South Texas Project
Units 1 and 2
Docket Nos. STN 50-498, STN 50-499
Responses to
Verbal NRC Questions on the FHAR

The attachments enclosed provide STP's response to Fire Hazards Analysis Report (FHAR) questions and comments that were verbally given to HL&P in a meeting on October 25, 1985.

South Texas Project
Units 1 and 2
Docket Nos. STN 50-498, STN 50-499
Responses to
Verbal NRC Questions on the FHAR

Figure 4-1

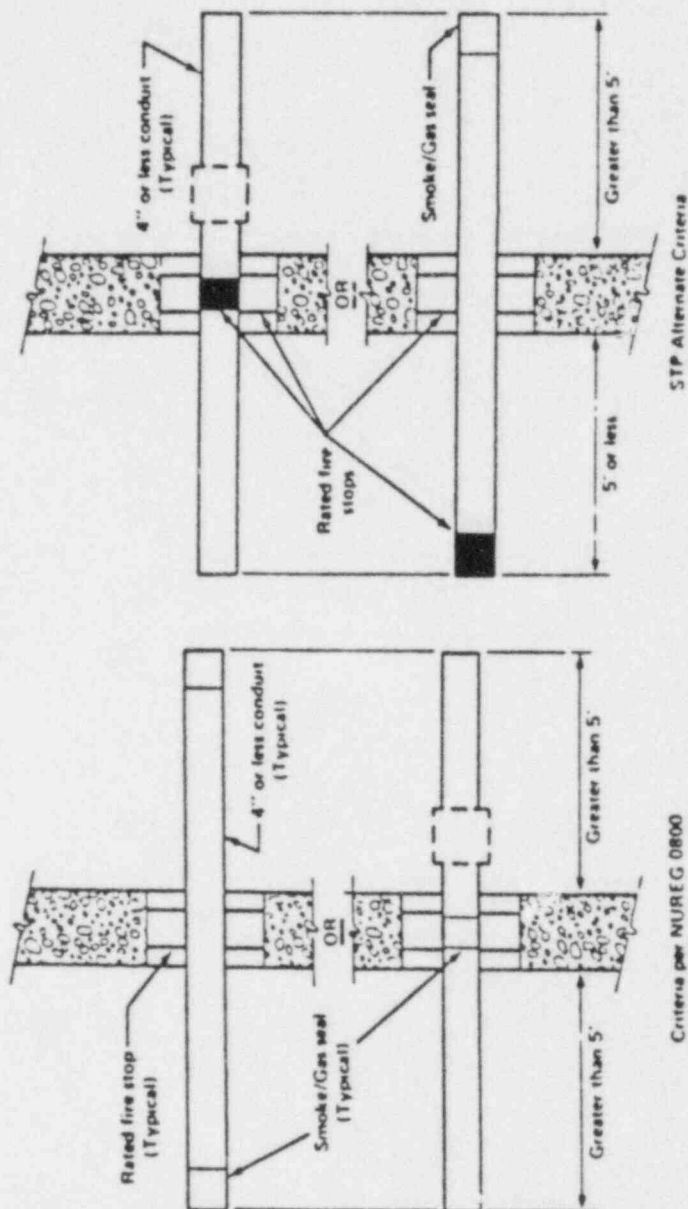
<u>Question</u>	<u>Section</u>	<u>Page</u>
22.	Fig 4.1

Specify where is this figure discussed.

Openings inside conduits 4 inches or less in diameter will be sealed at the fire barrier with a rated fire stop if the conduit terminates within 5 feet of the barrier or if access (e.g. conduit) is available within 5 feet of the fire barrier. If the conduit extends greater than 5 feet on each side of the barrier it will be sealed at both ends with noncombustible smoke/gas seals. See Figure 4-1, Penetration Seal Detail.

See the markup of Section D.3.d on page 4.2-30 which is attached to Question 6 of Part A.

LOGIC FOR DETERMINING THE TYPE OF FIRE SUPPRESSION SYSTEM, MANUAL OR AUTOMATIC, FOR ALL CABLE TRAYS OUTSIDE CABLE SPANNING ROOMS, POWER CABLE VAULT

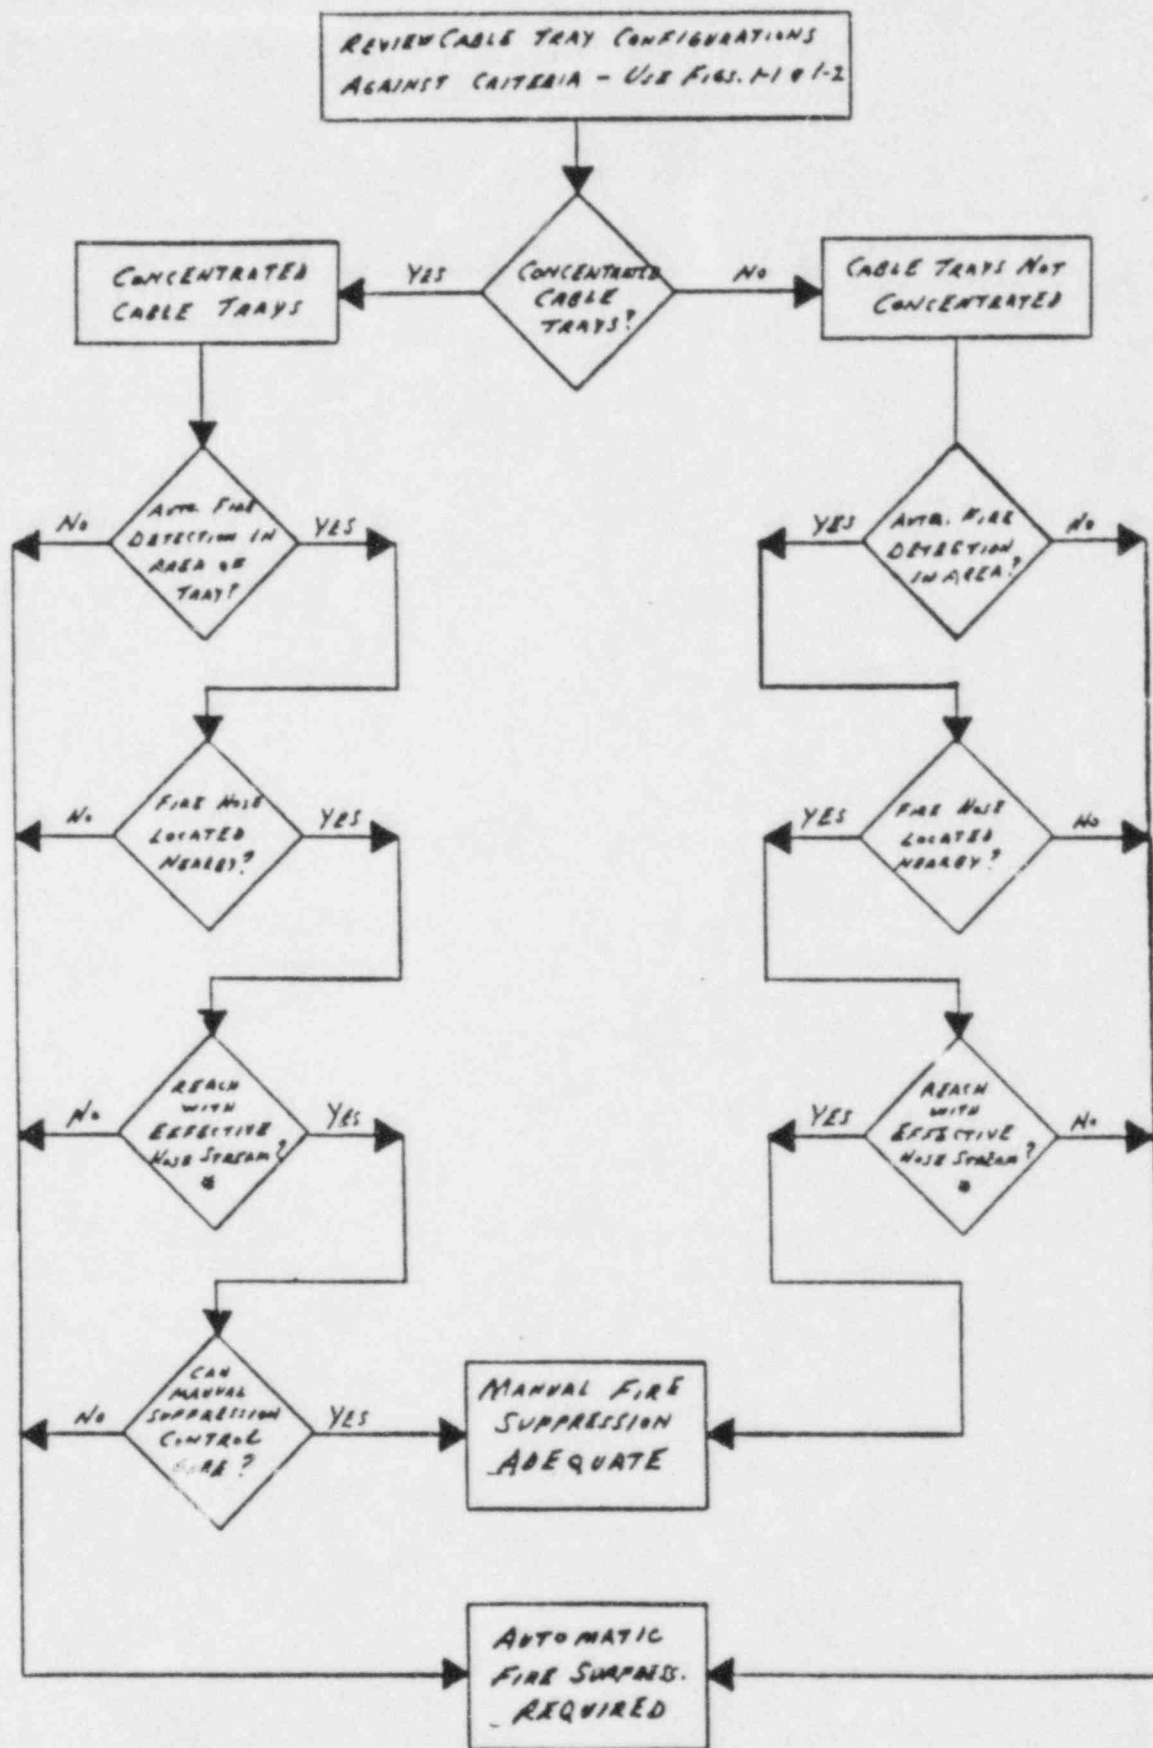
<u>Question</u>	<u>Section</u>	<u>Page</u>
2.	1.	Figure 1-2

Change the logic diagram as follows:

- a) Indicate that this review is done for all cable regardless of whether or not it is concerned.
- b) Change the last diamond to explain that this is to provide an effective hose stream to the fire.

A revised copy of Figure 1-2 is provided as Figure 1-3 which is attached to Question 7 of Part A.

Figure 4.11

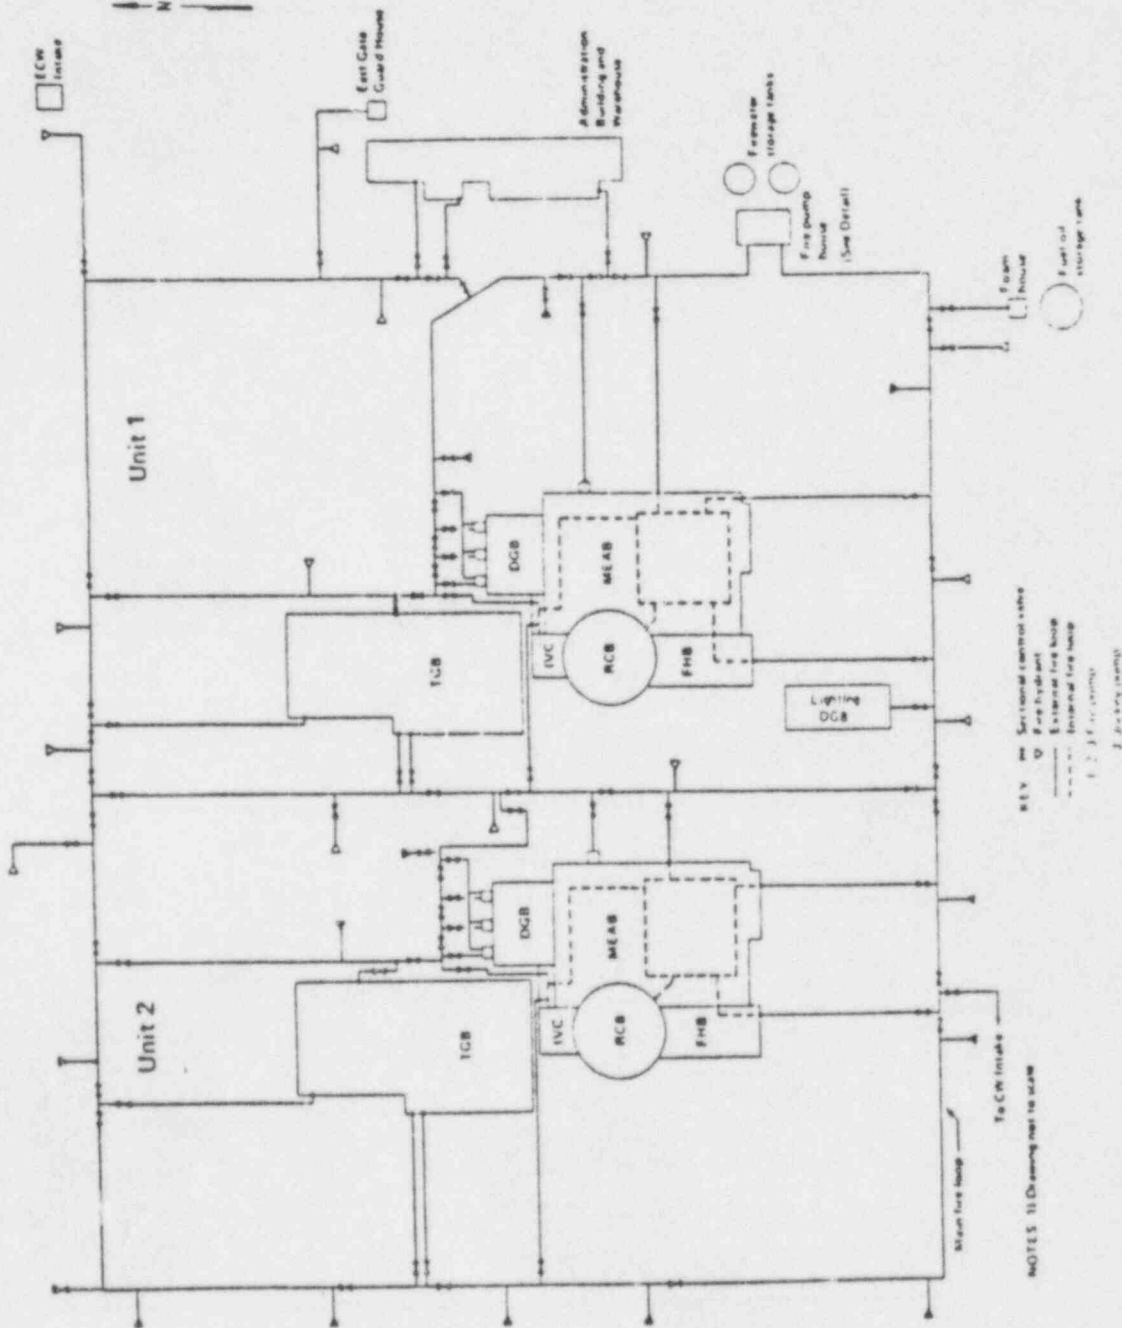
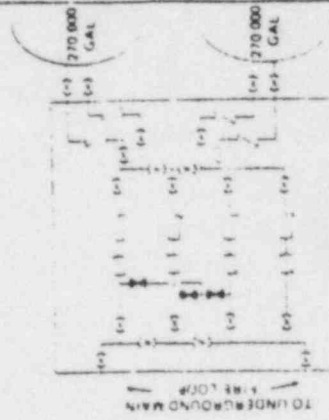
<u>Question</u>	<u>Section</u>	<u>Page</u>
1.	III.C	4.1-8

Sectional control valves are provided at appropriate points in the underground main fire loop which allow isolation of outside hydrant groups without interrupting water supply to any primary backup fire suppression systems in areas that contain or expose safety-related equipment. See Figure 4.1-1.

Attachment to SI-HL-17844
Examples of Configurations That are Concentrated

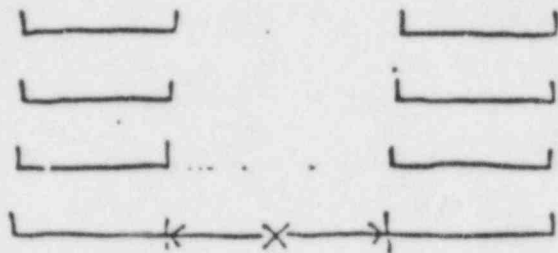
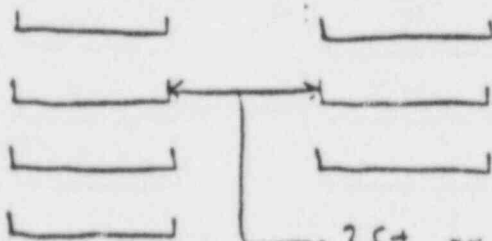
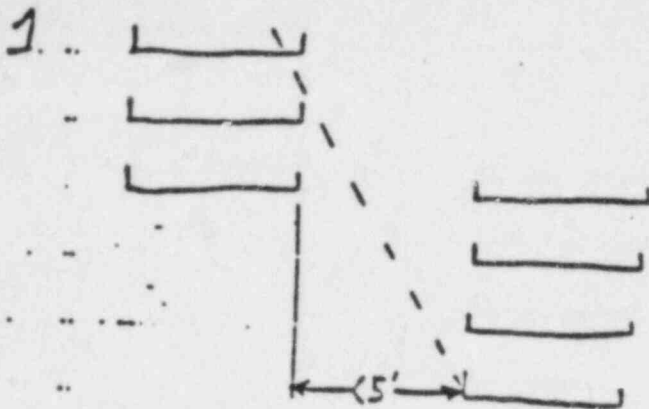
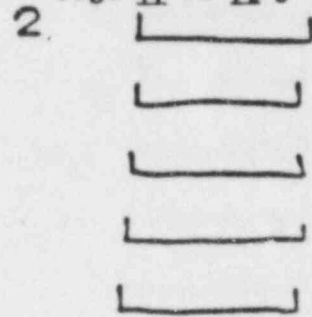
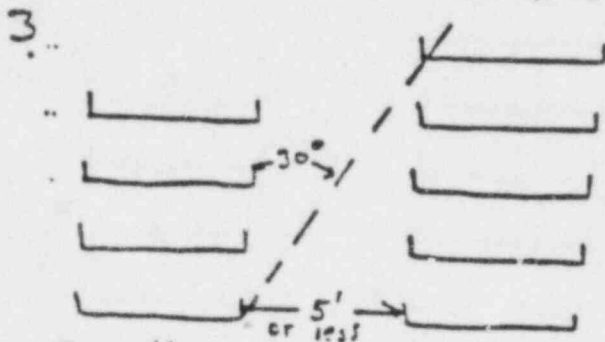
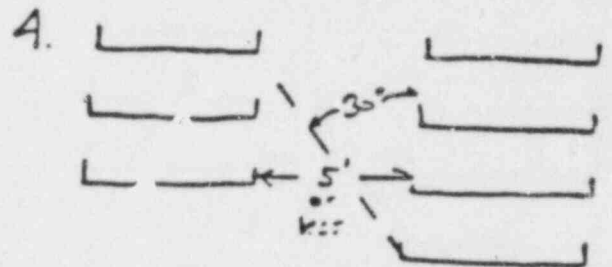
<u>Question</u>	<u>Section</u>	<u>Page</u>
1.	1.	Figure 1.1

Provide a copy of the ANI document providing the definition of concentrated cable trays.
